TENTATIVE AGENDA
CLEAR LAKE CITY COUNCIL
CITY HALL – 15 N. 6TH STREET
MONDAY, OCTOBER 17, 2011
CITY HALL – COUNCIL CHAMBERS
6:30 P.M.

CHANGE ORDER

Project Name: **Sanitary Sewer Collection System Improvement Project - Contract 1** Project Location: Clear Lake, Iowa
Underground Infrastructure Improvements

CLEAR LAKE FIRE STATION
STORMWATER HOLDING TANK CHANGE ORDER

DWG. NO. D.05
PROJECT 36374

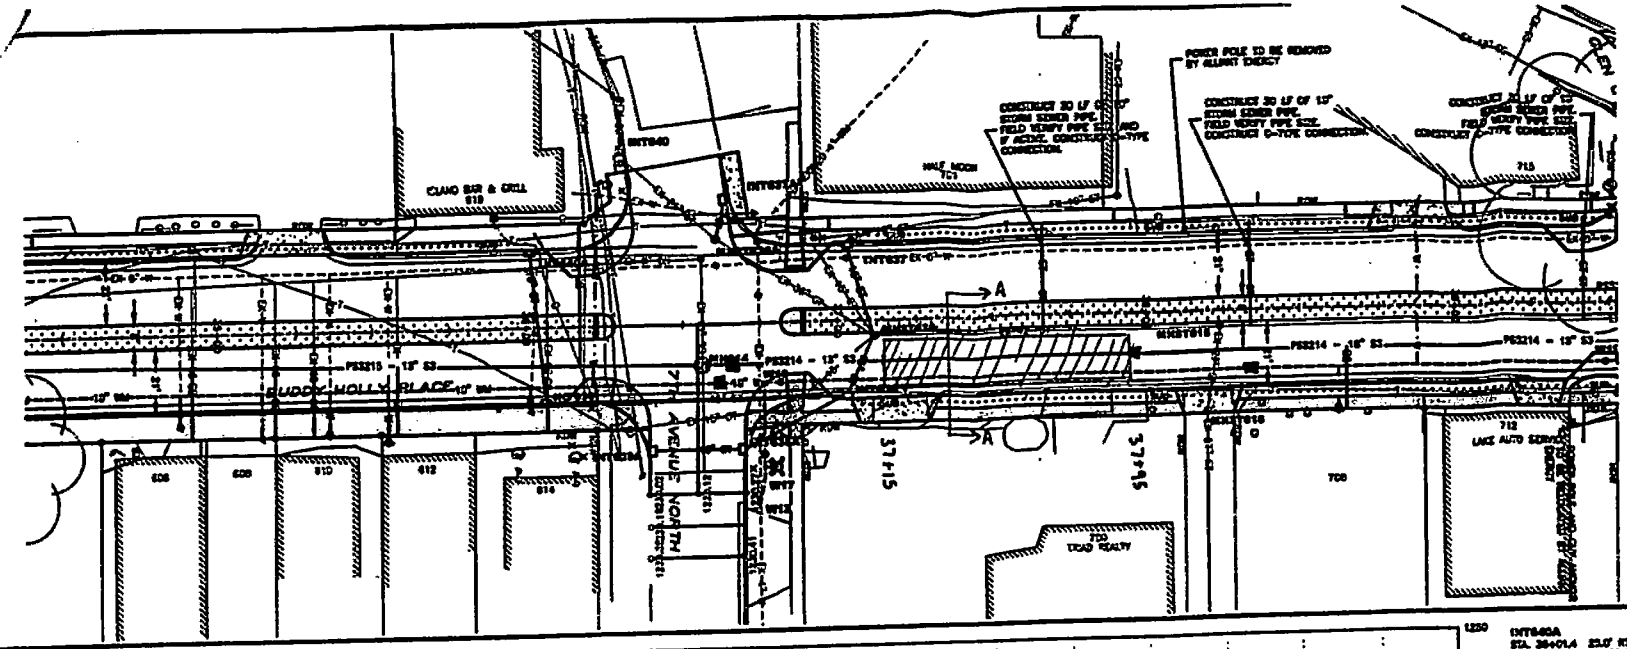
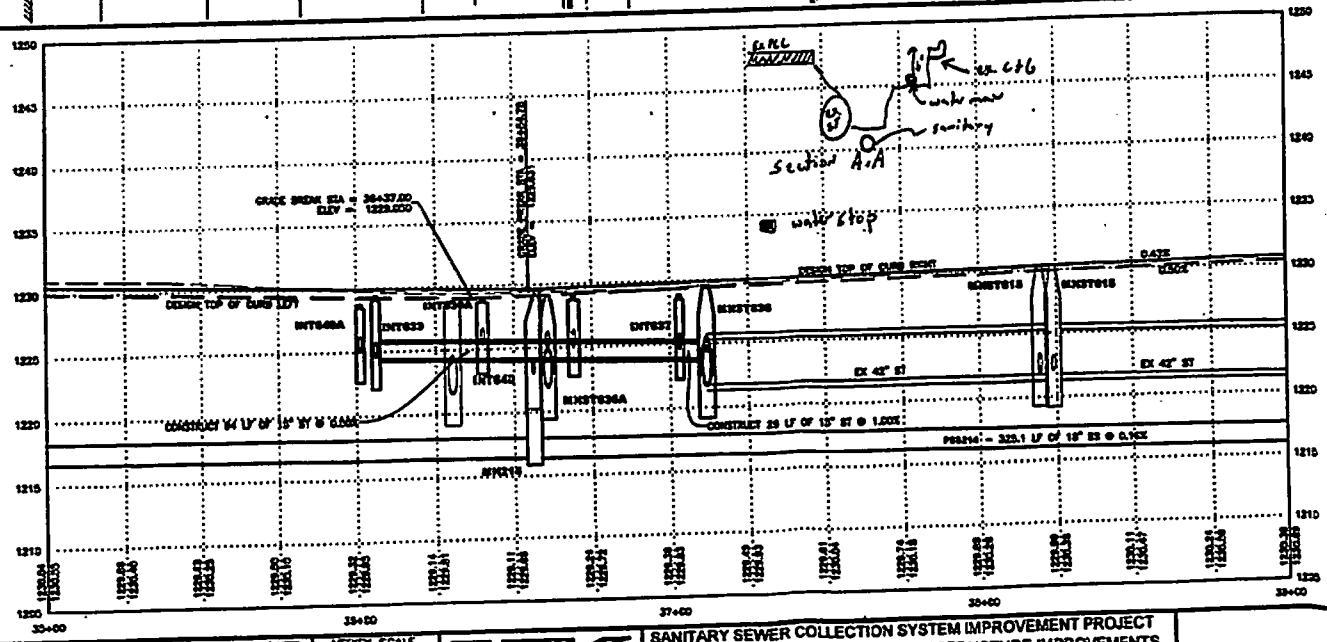
As a result of the contaminated soils discovered along Buddy Holly Place, Contractor directed to perform exploratory excavation for soil sampling and analysis and remove and dispose of contaminated soils. Contractor also required to import additional select soil materials provided by the City to replace the contaminated soils that were disposed of. To prevent the possibility of contamination following the trench bedding rock, water stops were installed at locations shown on Drawing D.05 attached. (Attachment A)

NOTES
ONLY DISTURBED SOILS MUST BE REMOVED.

Compensation to be in accordance with the contractors hourly rates for labor and equipment used to complete the work and reimbursement for the disposal of the contaminated soils at the landfill. Computed unit price per ton for hauling out contaminated soils and hauling in imported soils includes 10% markup for profit and overhead. Unit price per ton for disposal includes 5% for profit and overhead. A summary of the hourly rates and quantities of additional work required is attached (Attachment B). Also attached is Landfill of North Iowa's Invoice No. 20256 for the soil disposal noting the total tons of soil disposed (Attachment C).

13E WATER TANK SECTION

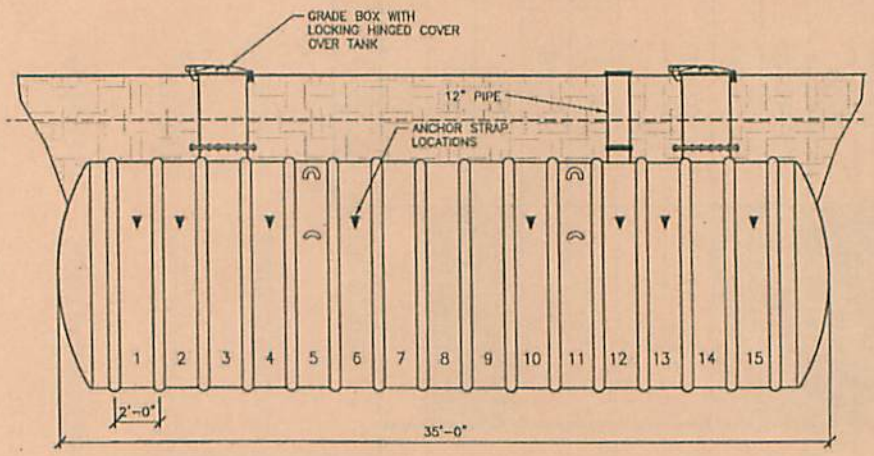
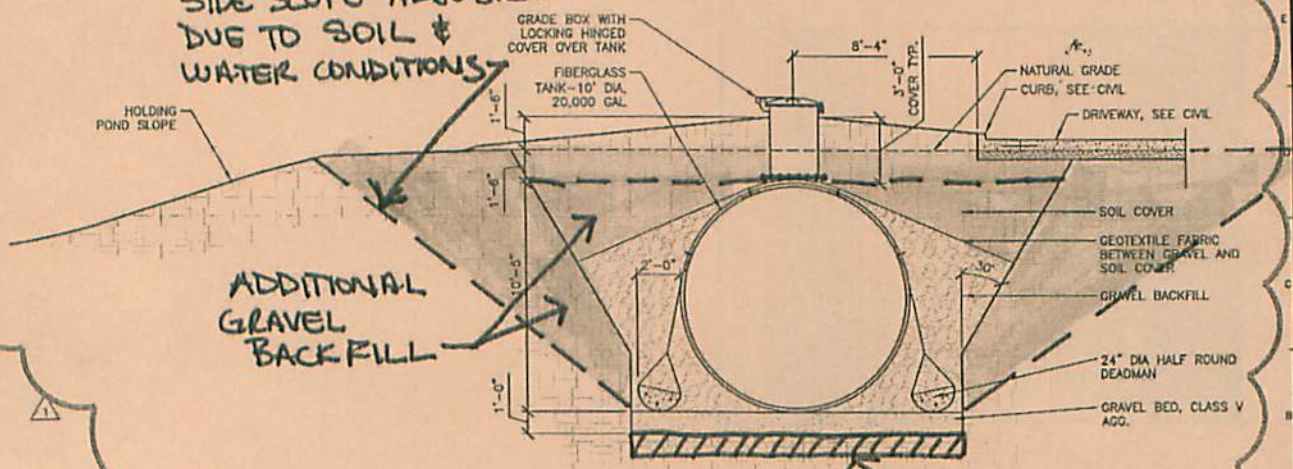
As requested, attached is a cost comparison for the as-bid versus as-installed costs associated with the installation of the tank along with a sketch showing the field adjustments needed because of the unforeseen conditions. Additional discussions with Henkel Construction did result in a reduction of the change order request of $6,001.23.

SIDE SLOPE ADJUSTED DUE TO SOIL & WATER CONDITIONS

ADDITIONAL GRAVEL BACKFILL

MACADAM FOR BASE

COST AS ESTIMATED DURING BIDDING =	$12,853.71
COST AS INSTALLED DURING CONSTRUCTION =	$30,768.68
DIFFERENCE IN COSTS =	$17,914.97
General Conditions (5%) =	$895.75
OH & P (10%) =	$1,791.50
Bond 1% =	$179.15
TOTAL =	$20,781.36
